ADDENDUM 1

Volume Calculation Package Addendum

Client: Honeywell **Project:** Onondaga Lake SCA Final Cover Design **Project/Proposal #:** GD5497

VOLUME CALCULATION PACKAGE ADDENDUM

Figure 1A: SCA Final Cover for Gently Sloping Areas on the Top and Main Decks

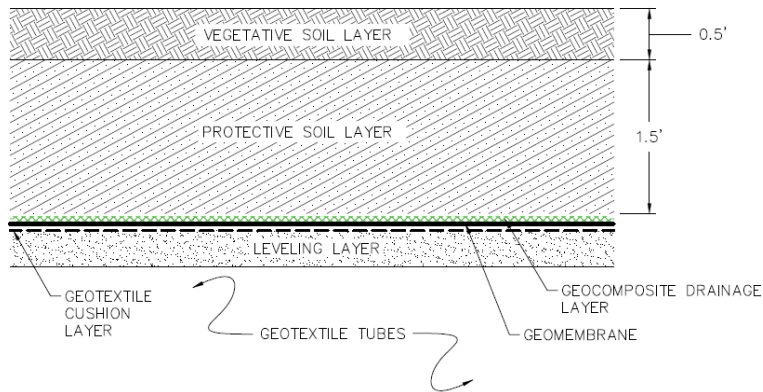
The Volume Package had indicated that the geocomposite drainage layer would only be used on the side slopes of the main deck. This addendum clarifies that the geocomposite drainage layer will be installed over the entire SCA cover area (i.e., top deck, main deck, and side slopes of both decks). Additionally, a geotextile cushion layer will be installed over the entire leveling layer surface. Therefore, Figures 1A and 1B, as shown below, have been updated to show that the SCA final cover system consists of the following layers¹:

- Leveling layer consisting of soil fill, with variable thickness as needed to establish design grades;
- Geotextile cushion layer;
- Linear low-density polyethylene (LLDPE) geomembrane;
- Geocomposite drainage layer;
- 18-inch thick protective soil layer; and
- 6-inch thick vegetative soil layer.
